NEBRASKA CAPITOL ENVIRONS COMMISSION

AGENDA

February 27, 2026

NEBRASKA CAPITOL ENVIRONS COMMISSION STAFF REPORT

LANDSCAPE PLAN
 J STREET PARKING LOT

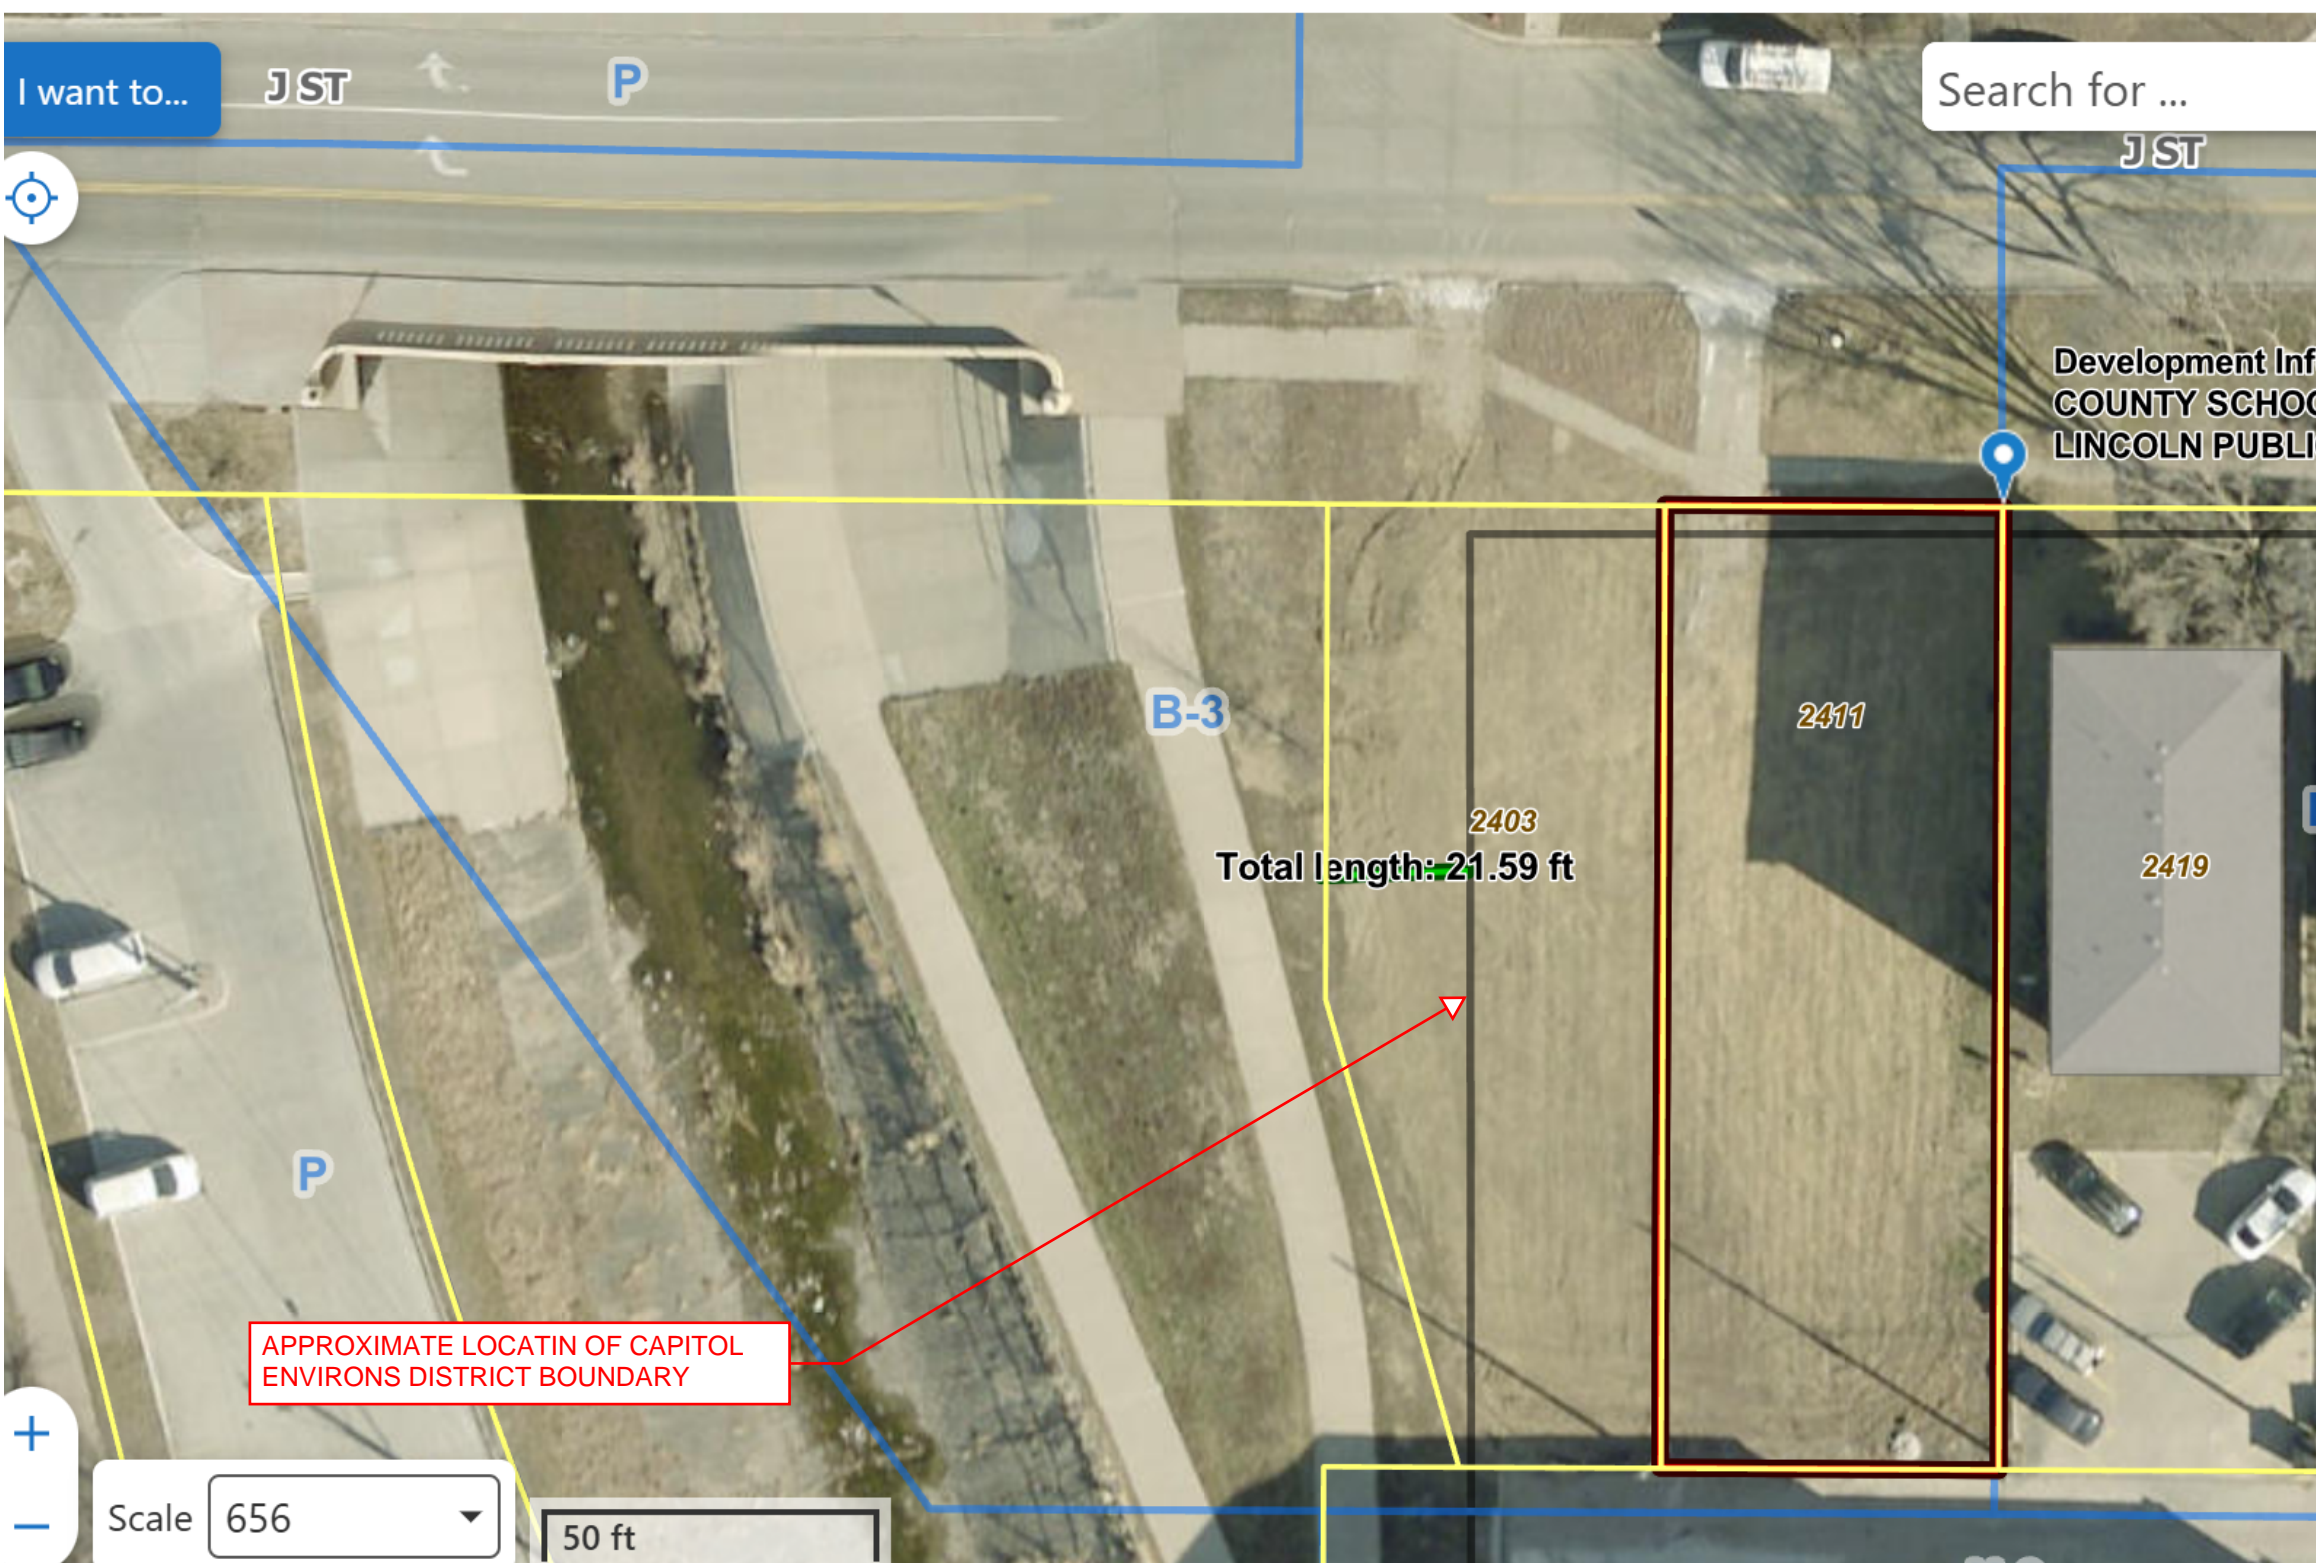
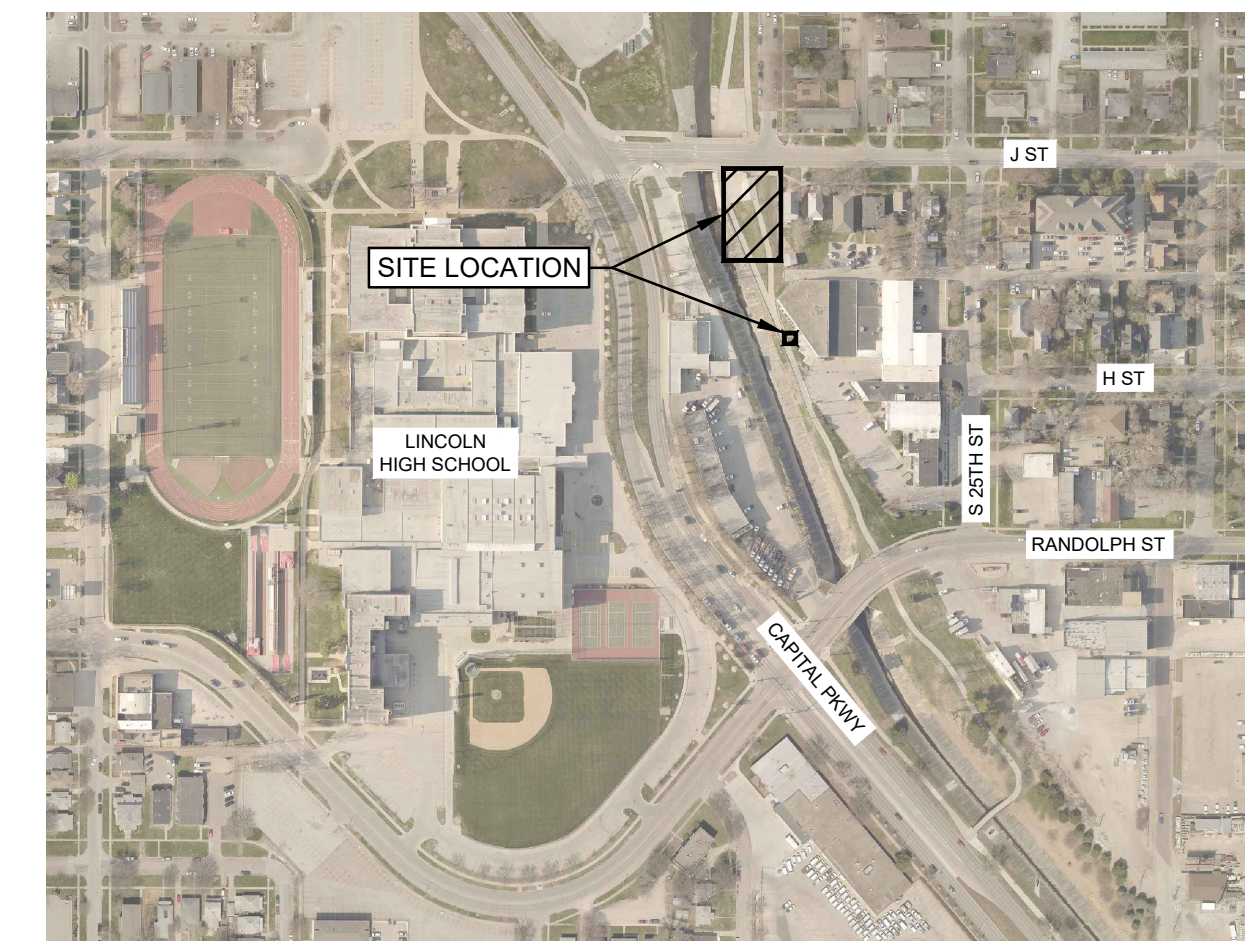
As the Commission knows, parking lots are generally discouraged in the district. When they are allowed, there is a high bar to meet. That said, staff is of the opinion that the site in question should be viewed with much more flexibility than one much closer to the Capitol might be. In discussions with the applicant, staff has emphasized the need to consider screening along the J Street frontage of the two lots in order to minimize the visual impact of this proposed parking lot.

The applicant is early in the design process but is moving quickly and would like to get some initial feedback on what will be expected for screening the parking lot. The initial plan they have submitted shows landscaping at the two north corners of the parking lot fronting J Street

As previously noted, LPS is exempt from typical landscape design standards, which would require landscaping around the entire perimeter of the parking lot. Further complicating the situation is the fact that the entirety of the parking lot itself is outside of the district. While the J Street design standards and guidelines have been copied below, this proposal might require a unique solution that meets the needs of the site and its position along the eastern edge of the district.

Staff is generally of the opinion that required landscaping should be limited to the portion of the parking lot bordering J Street, but any guidance for the applicant related to species selection, screen density, alternative materials or anything else that the Commission views as relevant should be discussed with the applicant.
